EPC STORMWATER REVIEW COMMENTS
IN ORANGE BOXES WITH BLACK TEXT

VOLLMER ROAD (NORTH)

STREET IMPROVEMENT PLAN

FEBRUARY 2023

VOLLMER ROAD
URBAN MINOR ARTERIAL CROSS SECTION
SCALE: NTS

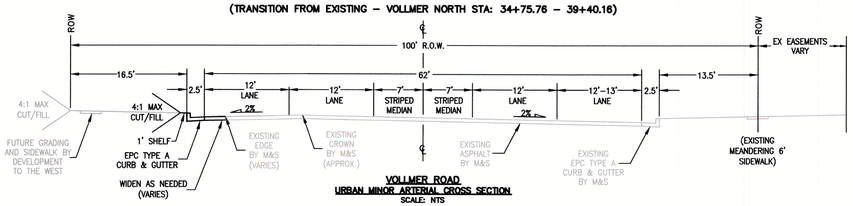
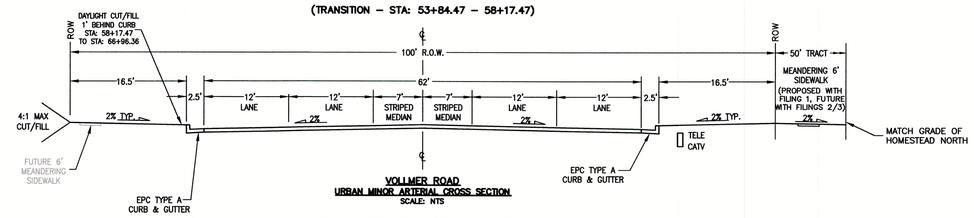
* - Per note on sheet 6, offsite drainage easement is required prior to Notice to Proceed and construction.

DP01 PROFILE
STA 0+00.00 TO 2+55.94

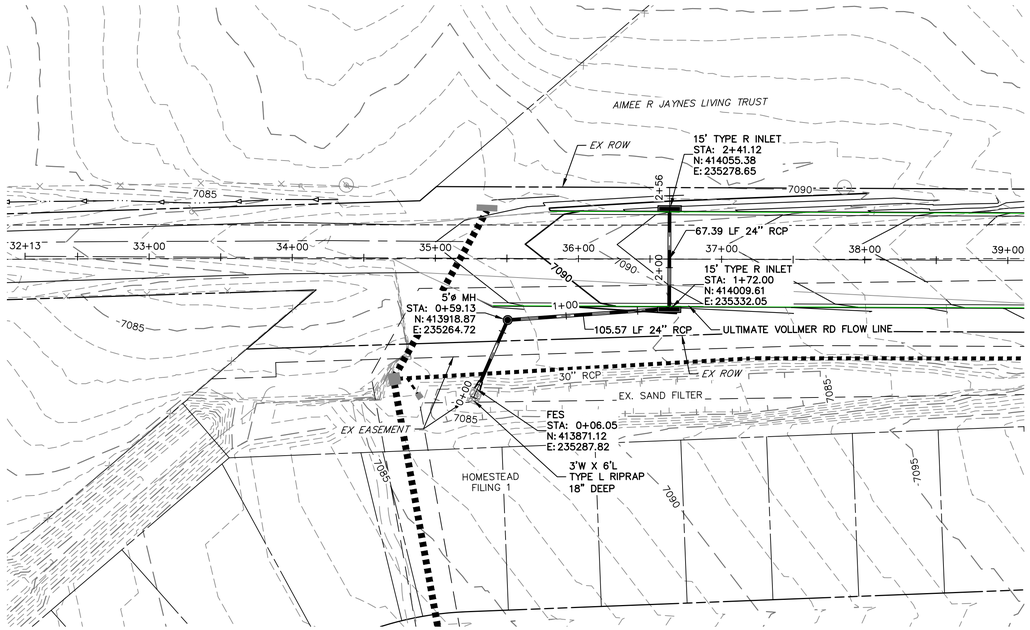
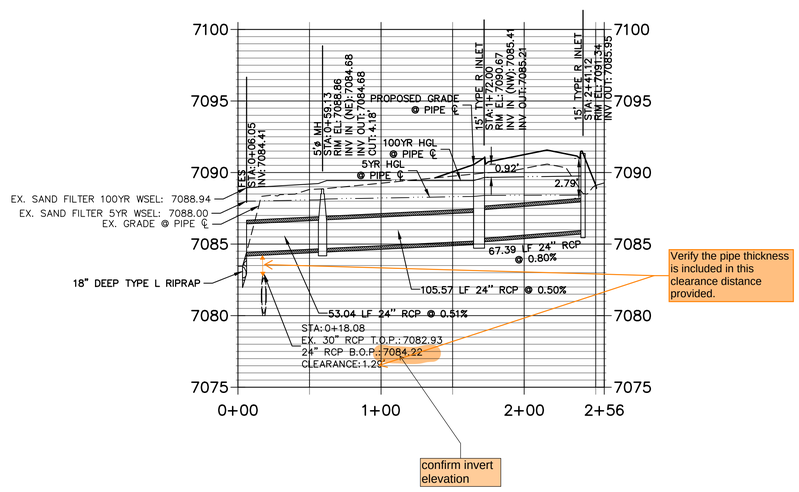
ADD WATER TIGHT JOINT
WHEN 100 YR HGL SHOWS
PIPE FULLY INUNDATED
